Access Compliance Report

Public Rights-of-Way

| Intersection ID: 15450 | Main Street: ALBEMARLE_RD | Cross Street: PIERSON_DR | Location: NE |
| ADA ID: 67A49E632526 | Ramp Type: Perp | Initial Pass/Fail: Fail | Overall Compliance: No |

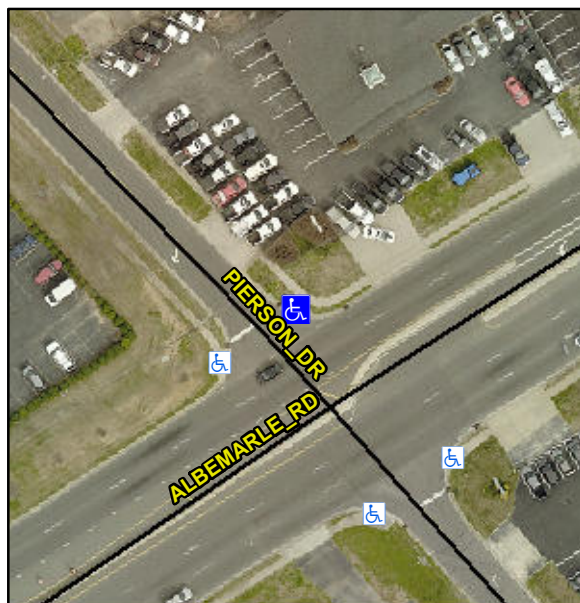
Surveyor Notes:

N/A

Not Found, R304.5.1

| Compliance | Description | Data | Compliance | Description | Data |
|------------|-----------------------|-------|------------|-----------------------------|------|
| No | Ramp Width (in) | 43.0 | Yes | Ramp XSlope (%) | 1.8 |

Remove & Replace Entire Ramp.
